Third Peer Review for New MGI Valves for NSTX-U (Update on Valve Testing and Installation Configurations on NSTX-U)

R. Raman, et al.

March 14, 2014

Installation Concept - 1

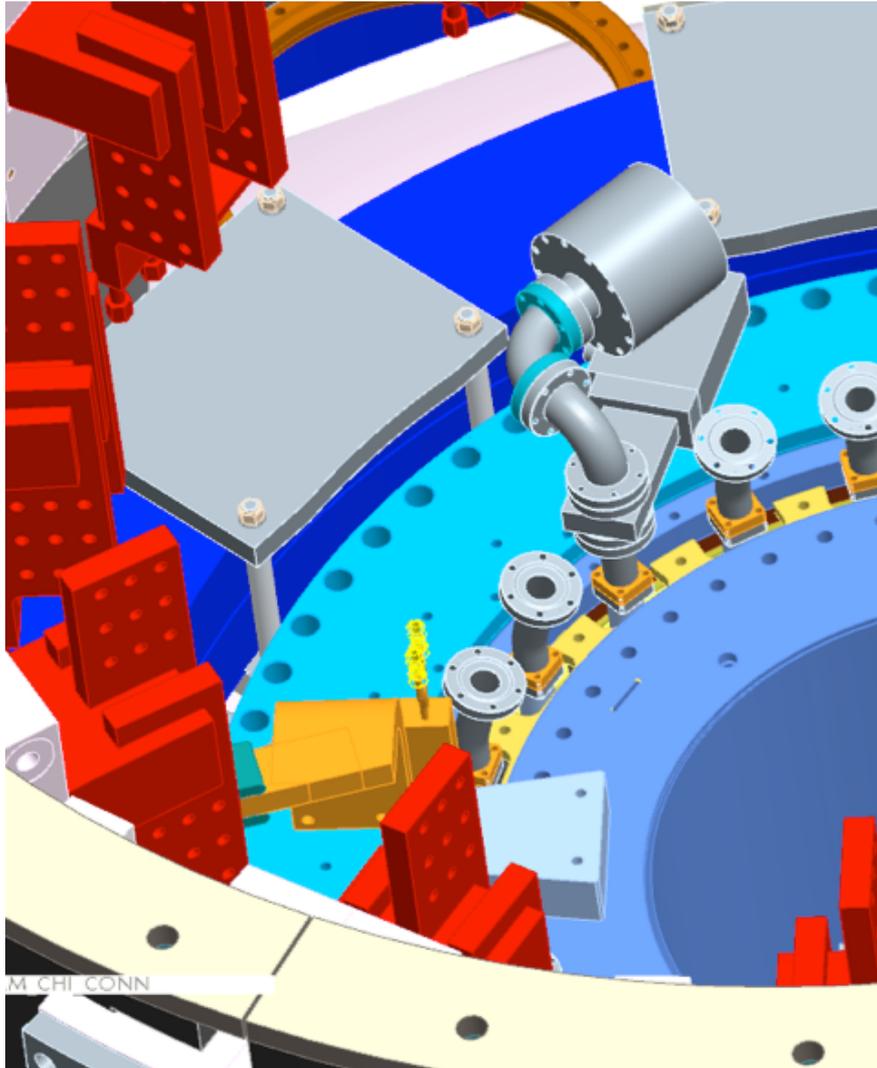
- Align the Valve so that the magnetic field is nearly perpendicular to the flat face of the piston
- This installation arrangement also avoids issue of lithium getting trapped near O-ring seals
 - Need to consider how to support current leads from the valve (2-5kA current, twisted pair)
 - Additional support for external valve body
 - Valve will be electrically isolated from vessel by a suitable insulating (non-ceramic) spacer (0.5 inch thick), and insulated bolt sleeves

Installation Concept – 1b

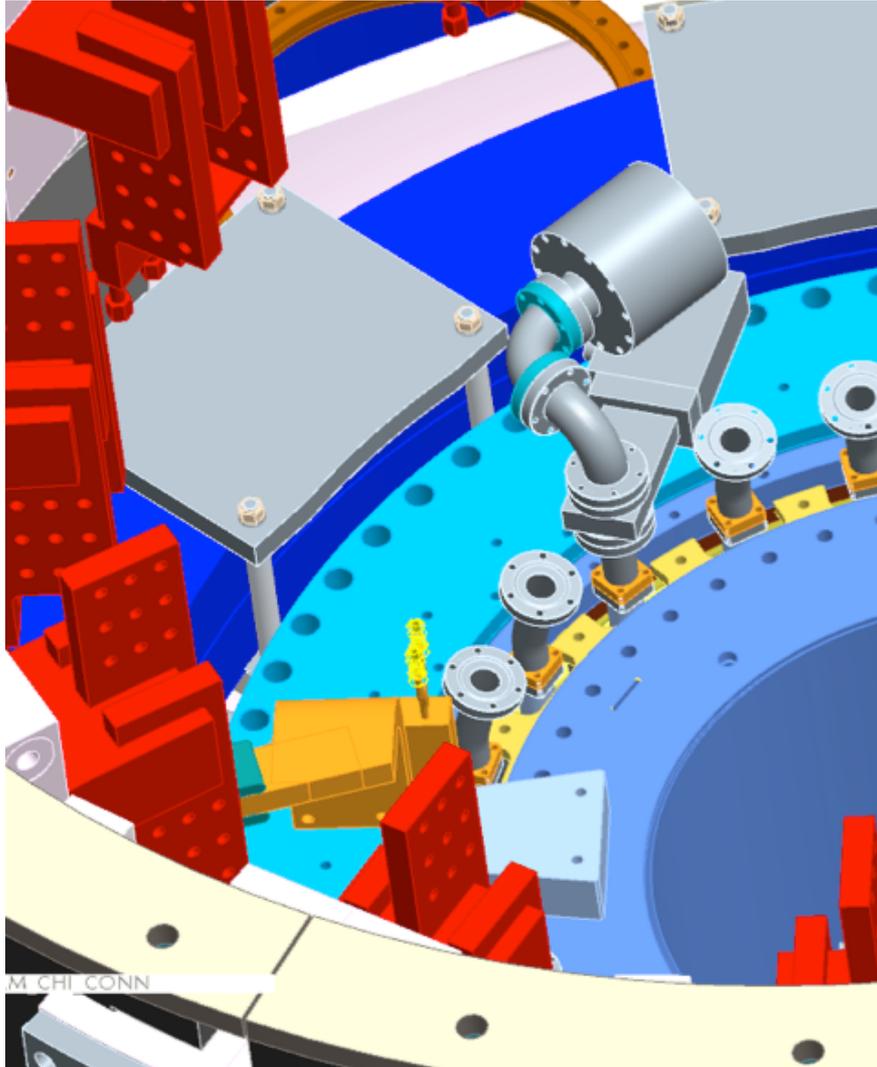
- In this case the tube bends will be extended to put the valve outside the TF coils to allow accessibility to valve
 - This is desired but to ensure that the valve can be maintained
 - Need to identify suitable path of tube through TF coil legs, and specify total tube length and the number of tube bends

Installation concept -2

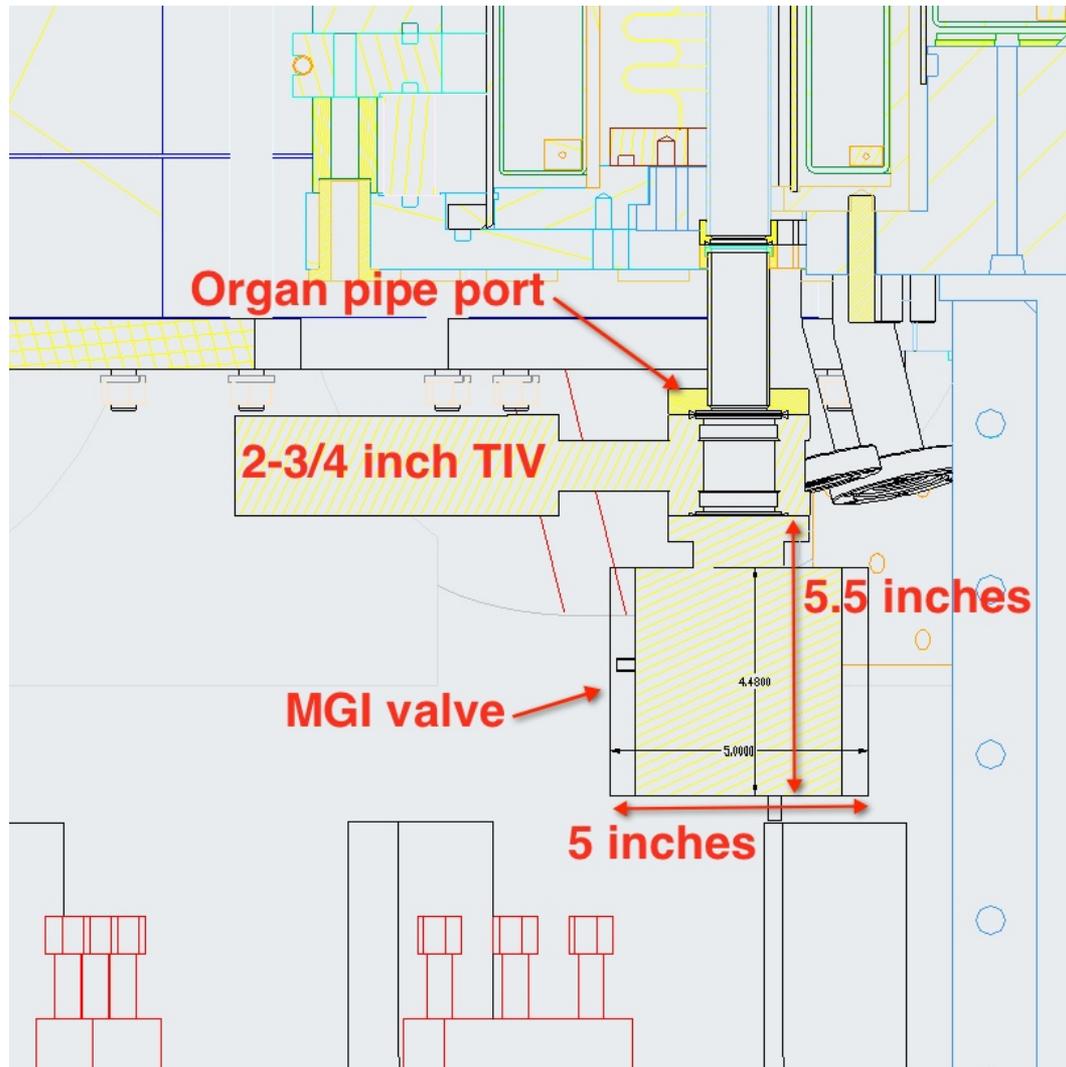
- Preferable to install one valve in this high-conductance configuration in upper divertor
 - Need TF/PF interlocks, similar to interlock to be used for CHI
- Will allow us to study the importance of valve proximity to plasma
- Will initially operate this valve in low B_T plasma with nearby PF coil de-energized
 - Will gradually increase magnetic fields to higher levels
 - Off-line tests in magnetic fields will provide supporting data
 - Mid-plane valve arrangement can be changed before experiments to assume either a low conductance or a high conductance configuration.

Installation concept -3 (Reduced Conductance – Valve is 135 cm below Divertor Plate)

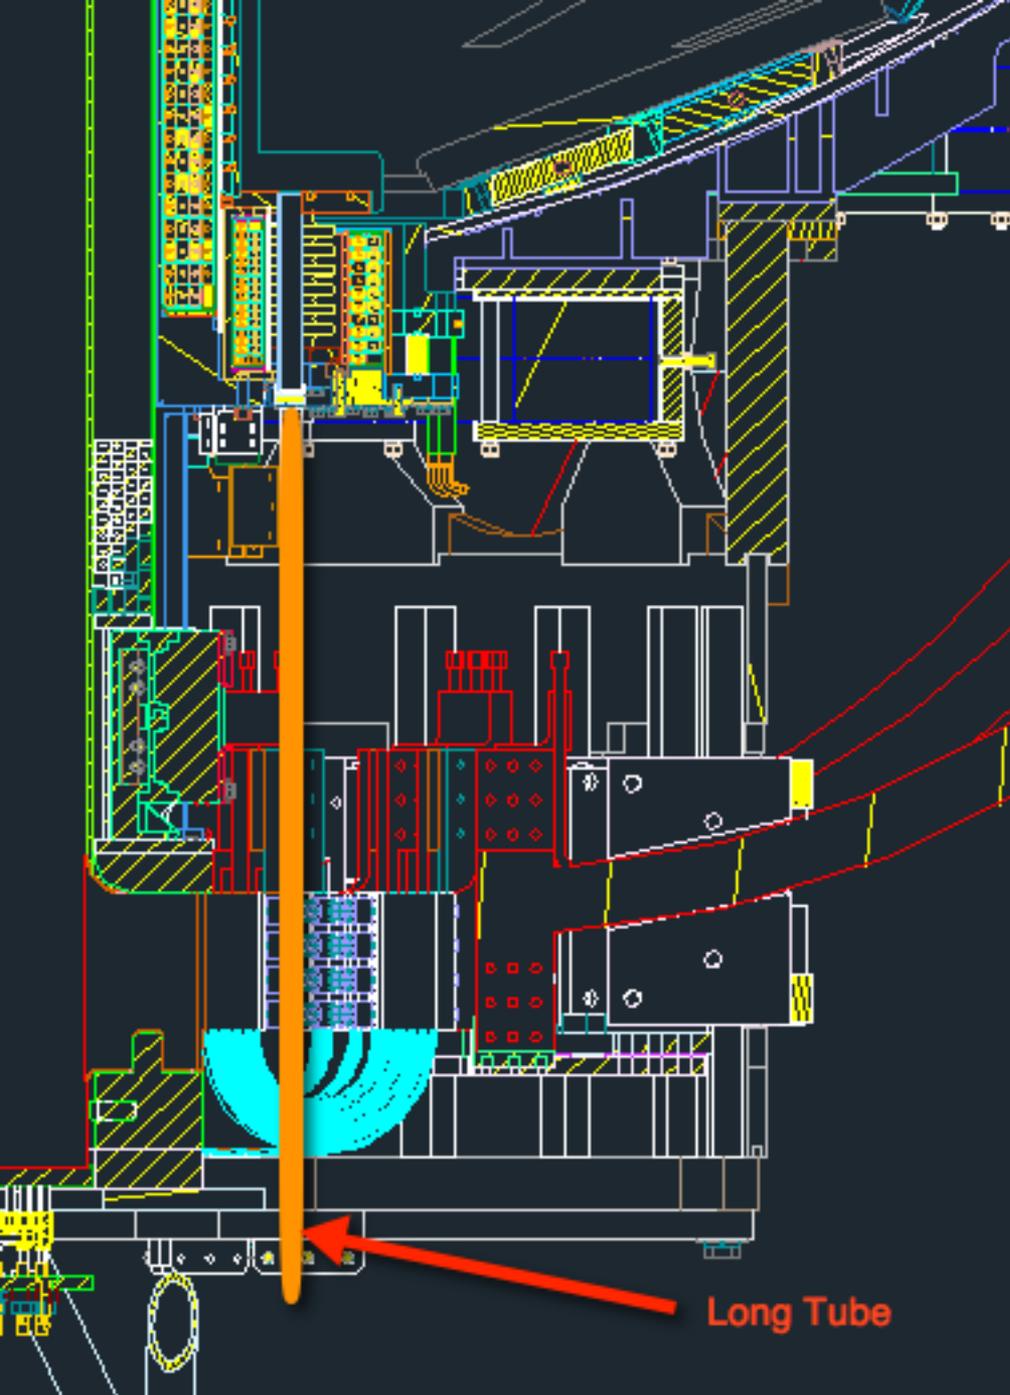
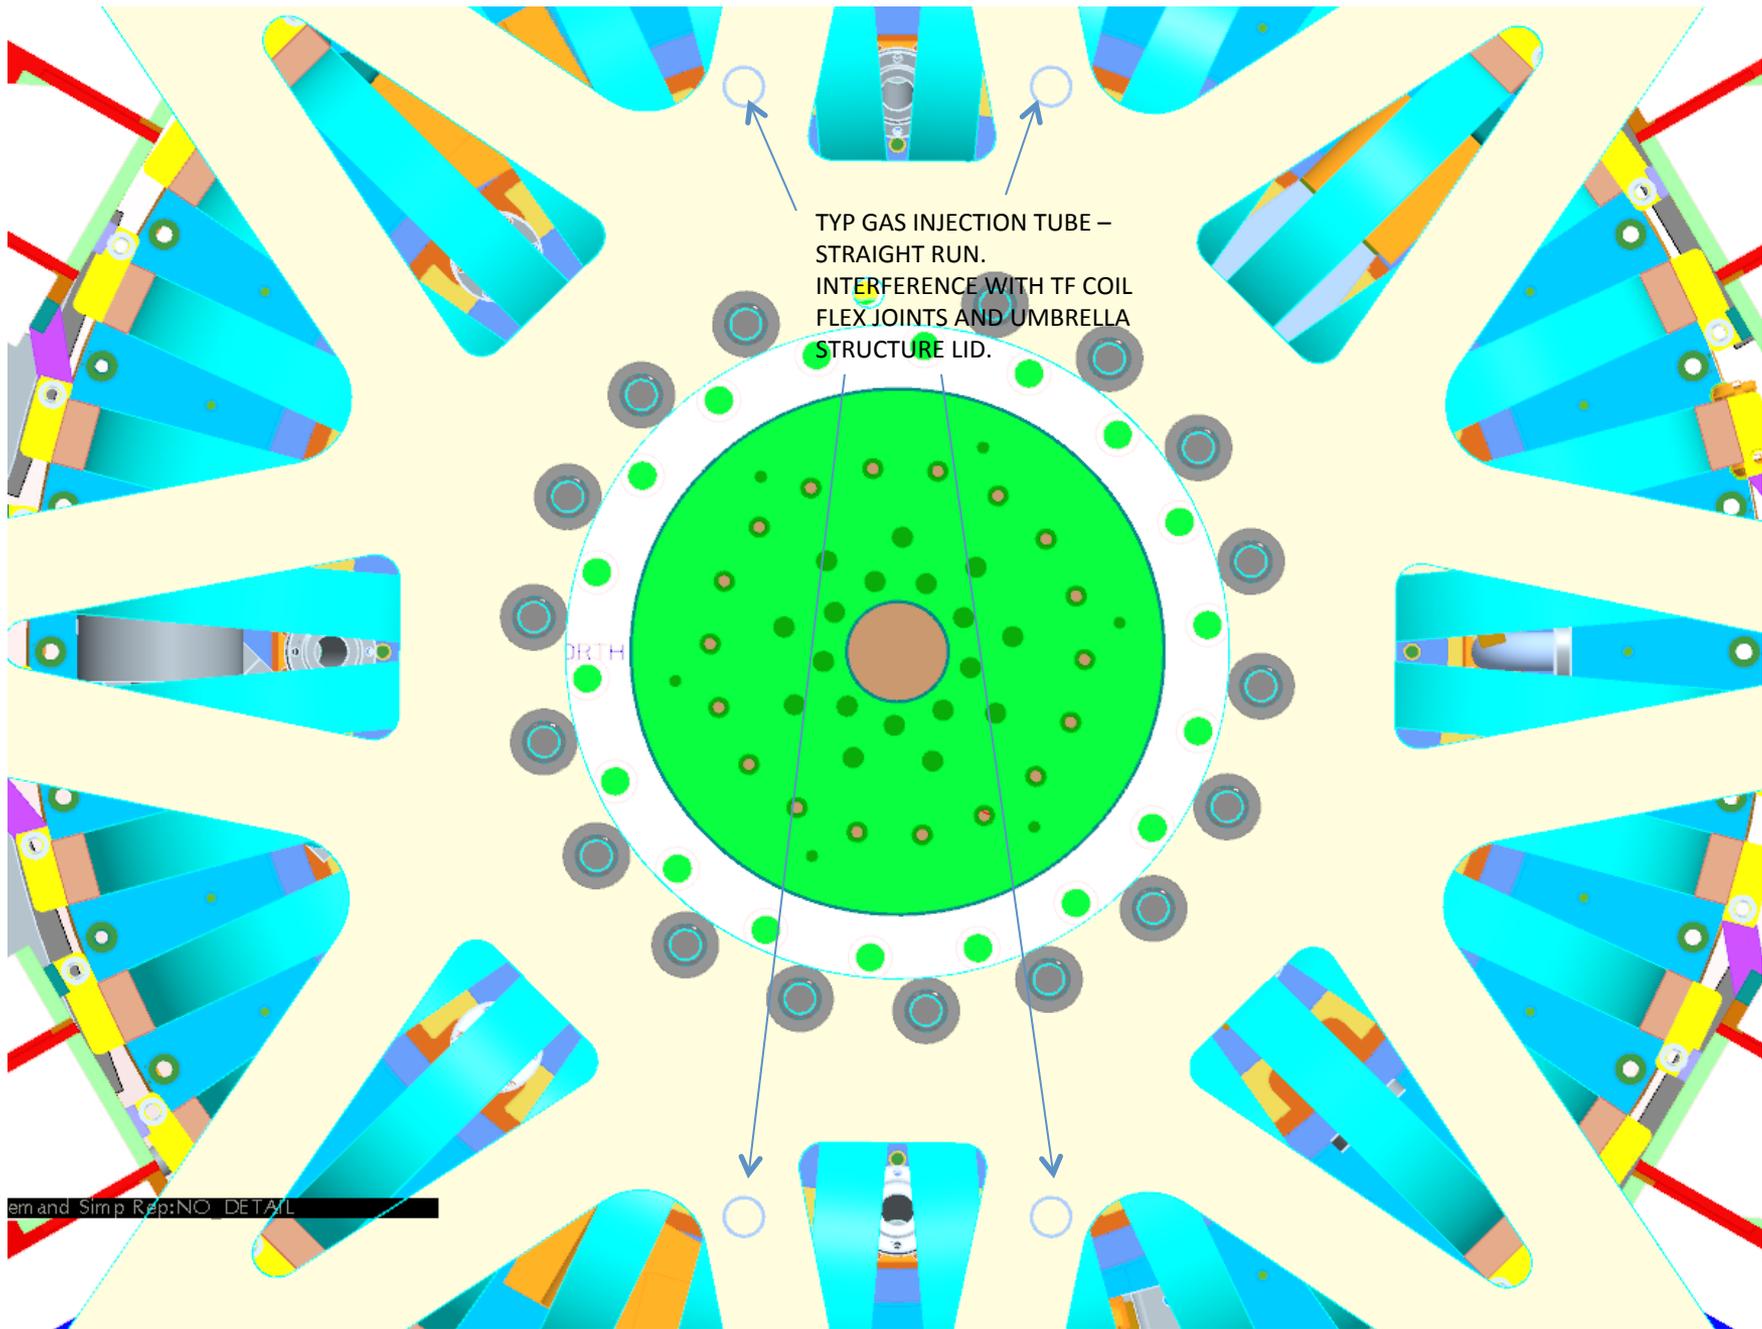
- Almost straight through tube preferable to tube with bends to increase conduction (see next three slides from Lew Morris)
- Need to keep tube ID close to valve orifice ID of ~1 inches throughout length
 - Preferable to add lower diameter (2.5cm) adapter tube inside the organ pipe (based on DIII-D results)
 - Needs to identify extent of tube bends and total tube length to compare to case 1b

TYP GAS INJECTION TUBE –
STRAIGHT RUN.
INTERFERENCE WITH TF COIL
FLEX JOINTS AND UMBRELLA
STRUCTURE LID.

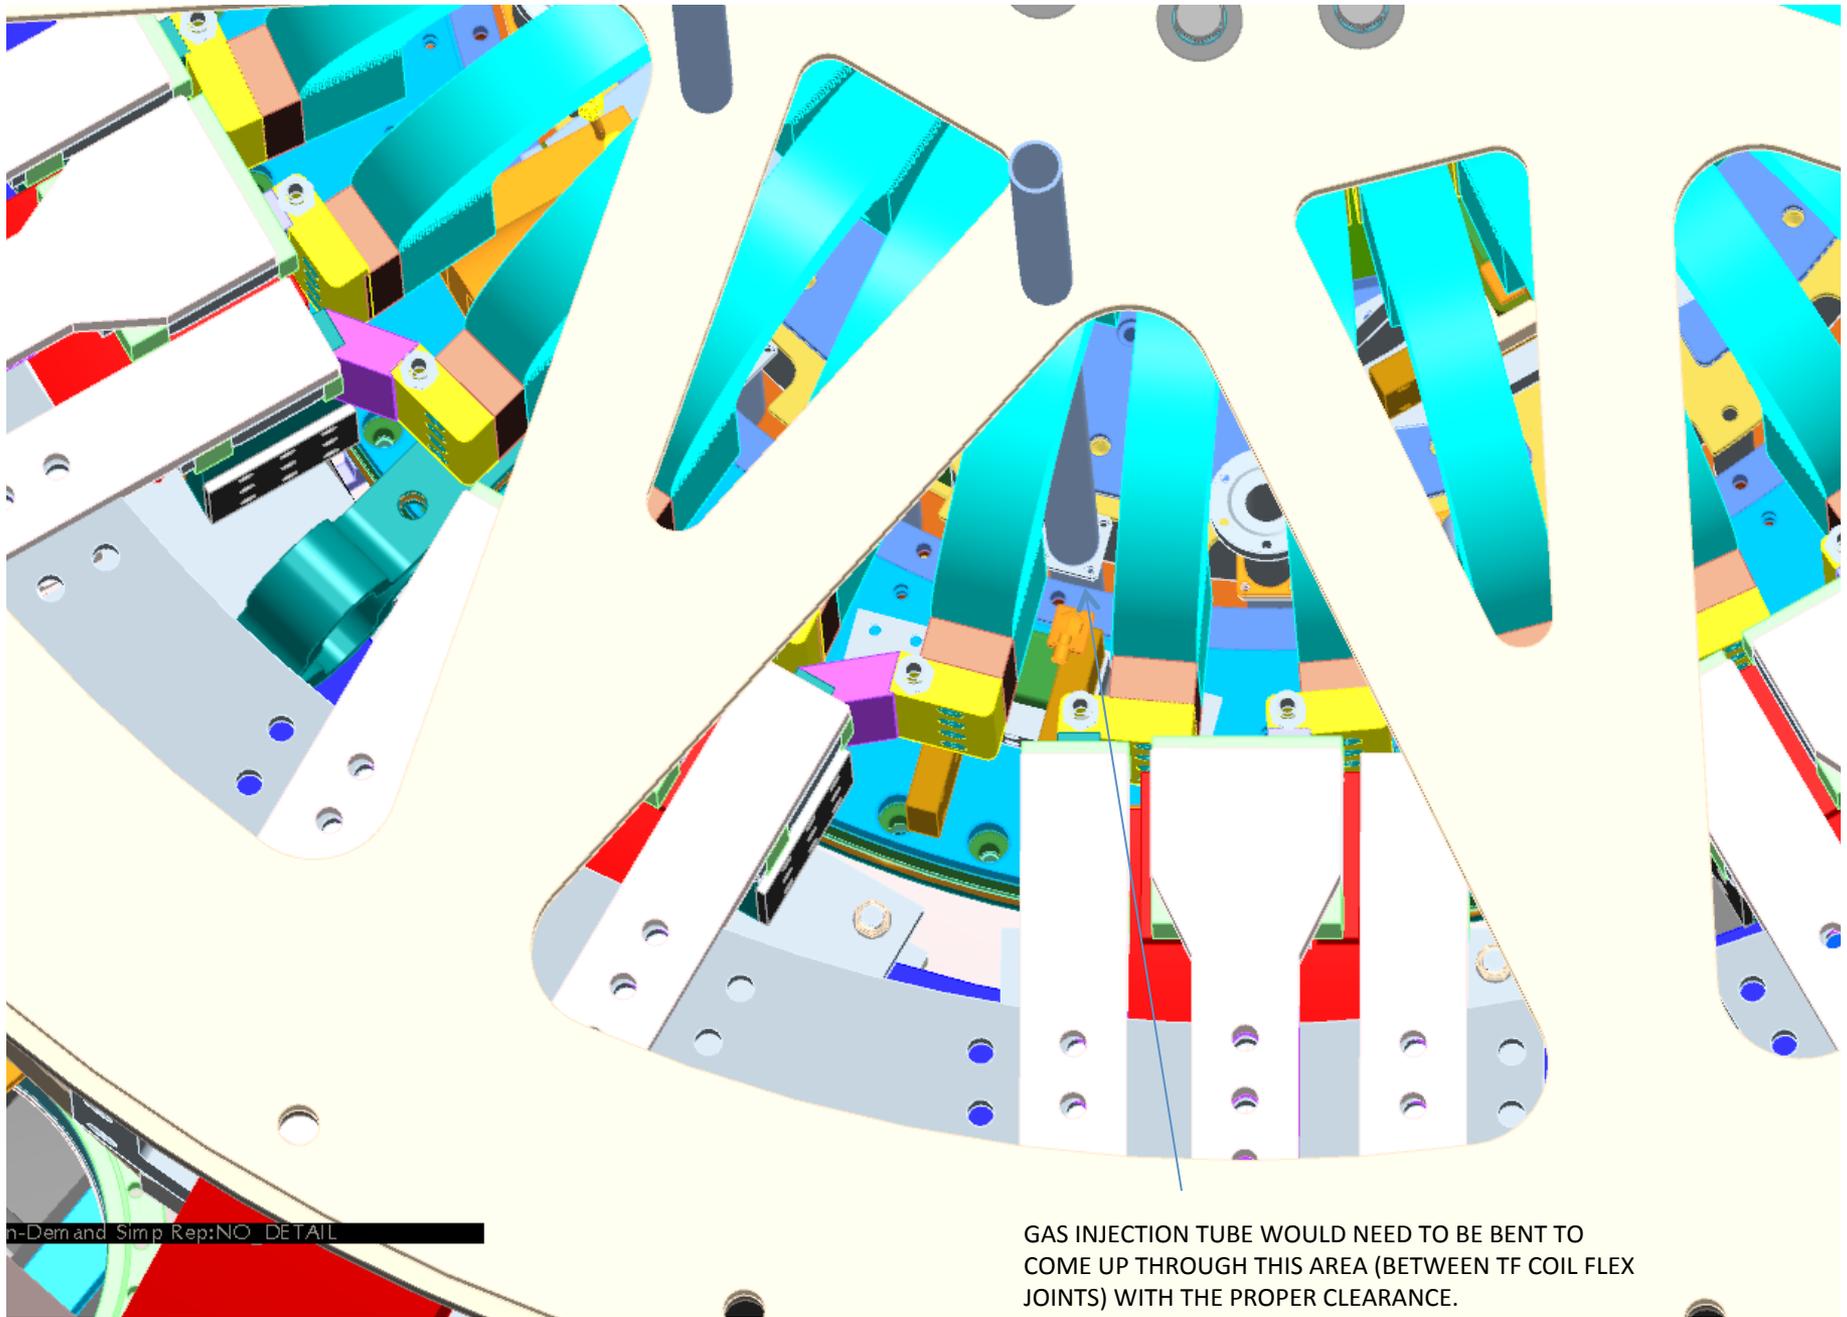
GAS INJECTION TUBE WOULD NEED TO BE BENT TO COME UP THROUGH THIS AREA (BETWEEN TF COIL FLEX JOINTS) WITH THE PROPER CLEARANCE.

GAS INJECTION TUBE WOULD NEED TO BE BENT TO COME UP BETWEEN TF COIL FLEX JOINTS AT THIS APPROXIMATE LOCATION.
